Preparatory Study for Development of
 Southern Large Scale Thermal Power Plant
 in IRAQ
 1,800MW Class
 Gas Combined Cycle Power Plant
 2 on 1 Multi-Shaft
 (ACC Case)
 Conceptual Plot Plan

Attachment - 9 Nasiryah I Conceptual Plant Layout

DWG No. 143 E 9054, Rev.G
JICA MARK-UP
Rev.1 (Feb-12-2012)

TITRE/TITLE
ENGINEERING DOCUMENTATION
CONCEPTUAL
PLANT LAYOUT

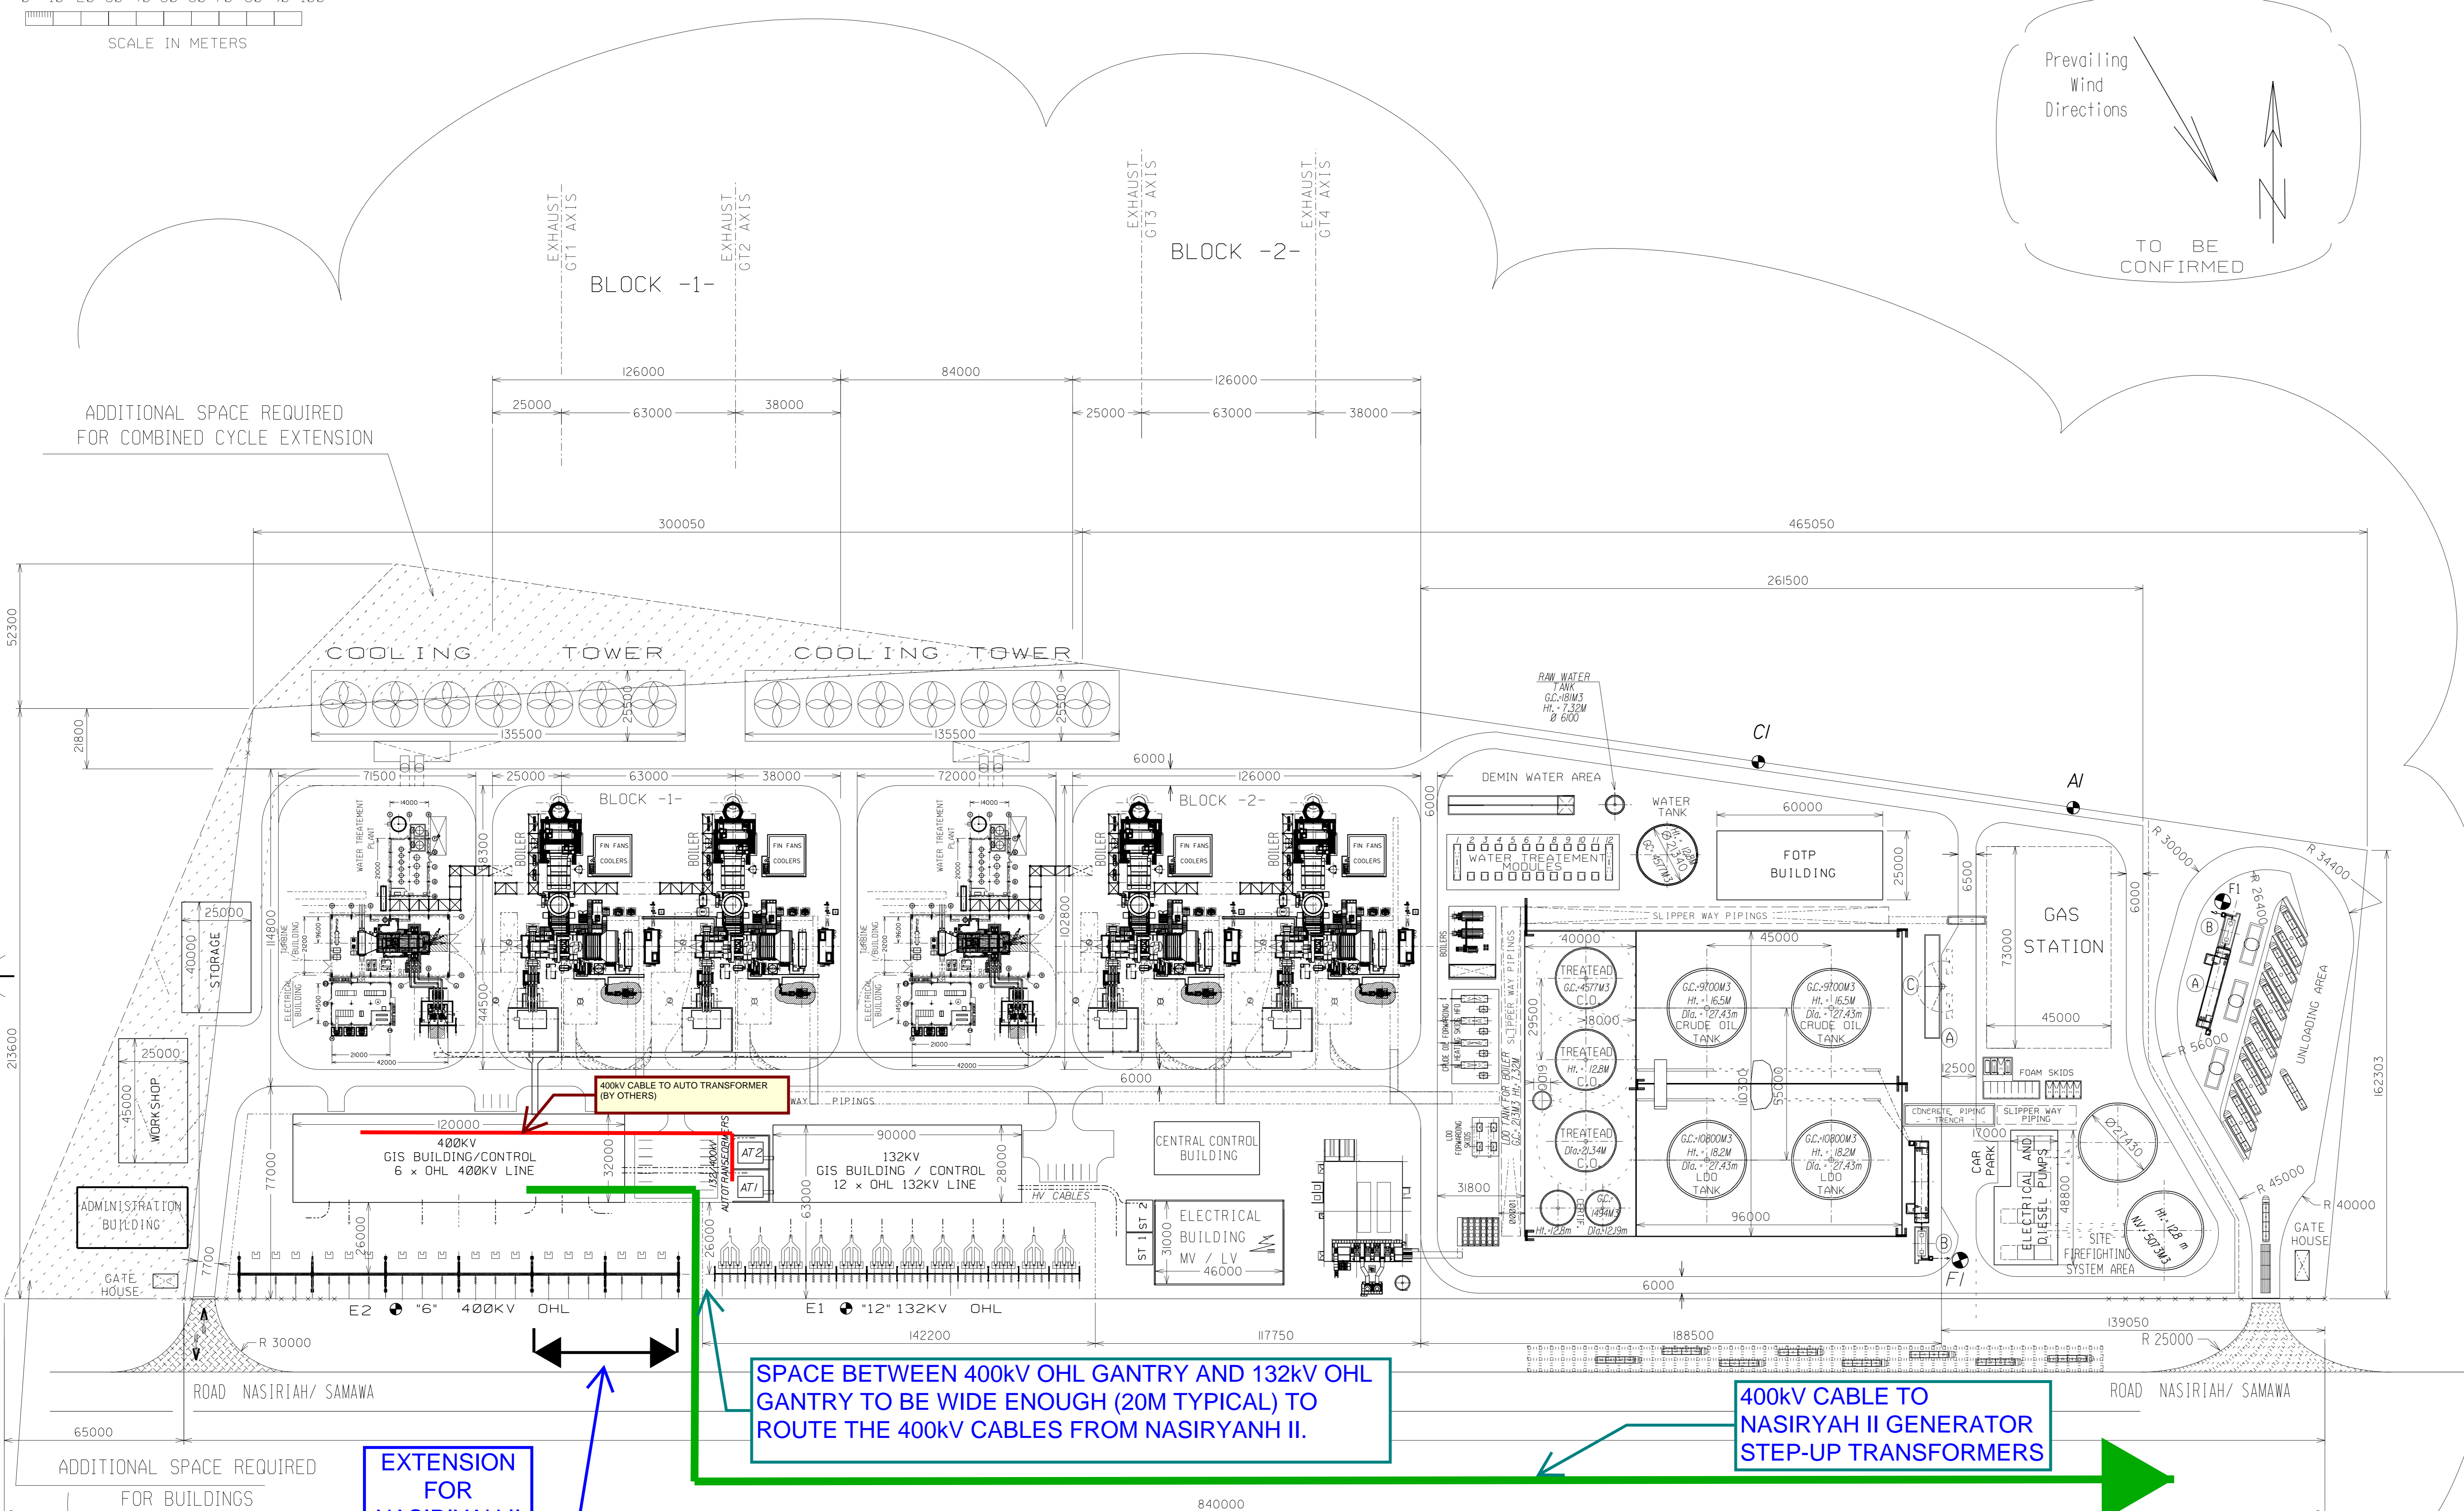
EXTENSION FOR NASIRIYAH II PROJECT OHL

SPACE BETWEEN 400KV OHL GANTRY AND 132KV OHL GANTRY TO BE WIDE ENOUGH (20M TYPICAL) TO ROUTE THE 400KV CABLES FROM NASIRYANH II.

400KV CABLE TO NASIRIYAH II GENERATOR STEP-UP TRANSFORMERS
